Access Compliance Report Public Rights-of-Way (Curb Ramps)

Intersection ID: 53504	Main Street: CRIPPLE_CREEK_LN	Cross Street: ALLISON_LN	Location: NW
ADA ID: 5D84BECB0DEF	Ramp Type: Perp	Initial Pass/Fail: Fail	Overall Compliance: No Severity Score: 33.75

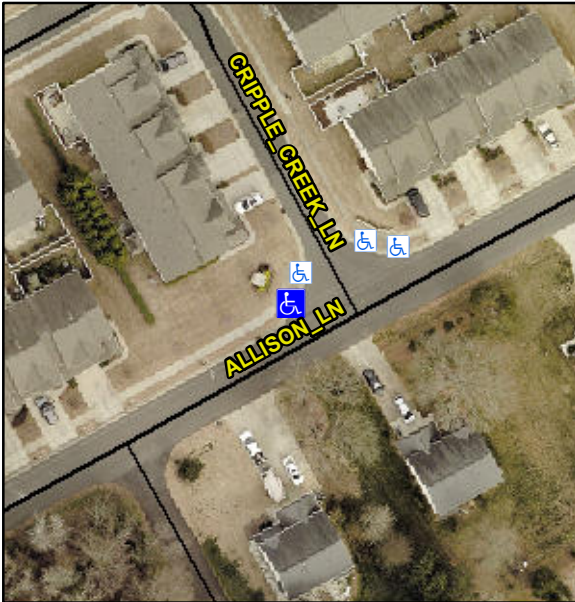
Not Found, R304.5.1, R304.2.2, R304.5.3

Compliance	Description	Data	Compliance	Description	Data
N/A	Ramp Length (in)	48.0	No	Ramp Slope (%)	8.8
No	Ramp Width (in)	46.5	No	Ramp XSlope (%)	5.8
N/A	Flare Type LT	N/A	N/A	Flare Type RT	N/A
N/A	Flare Slope LT (%)	N/A	N/A	Flare Slope RT (%)	N/A
N/A	Flare Traversable LT?	N/A	N/A	Flare Traversable RT?	N/A
N/A	Landing Length (in)	N/A	N/A	DWS Provided?	N/A
N/A	Landing Width (in)	N/A	N/A	DWS Contrast?	N/A
N/A	Landing Slope (%)	N/A	N/A	DWS Length (in)	N/A
N/A	Landing X Slope (%)	N/A	N/A	DWS Full Width?	N/A
N/A	Landing Curb? (Y/N)	N/A	N/A	DWS Offset (in)	N/A
N/A	Shared Landing?	N/A			
N/A	Gutter Ponding?	N/A	N/A	Gutter Slope (%)	N/A
N/A	Gutter Lip Ht (in)	N/A	N/A	Gutter X Slope (%)	N/A
N/A	Painted X Walk1?	No	N/A	Painted X Walk2?	N/A
	X Walk 1 Direction	To SW		X Walk 2 Direction	N/A
N/A	X Walk 1 Width (in)	N/A	N/A	X Walk 2 Width (in)	N/A
	X Walk 1 Slope (%)	1.9		X Walk 2 Slope (%)	N/A
	X Walk 1 X Slope (%)	6.4		X Walk 2 X Slope (%)	N/A

Remove & Replace Entire Ramp.
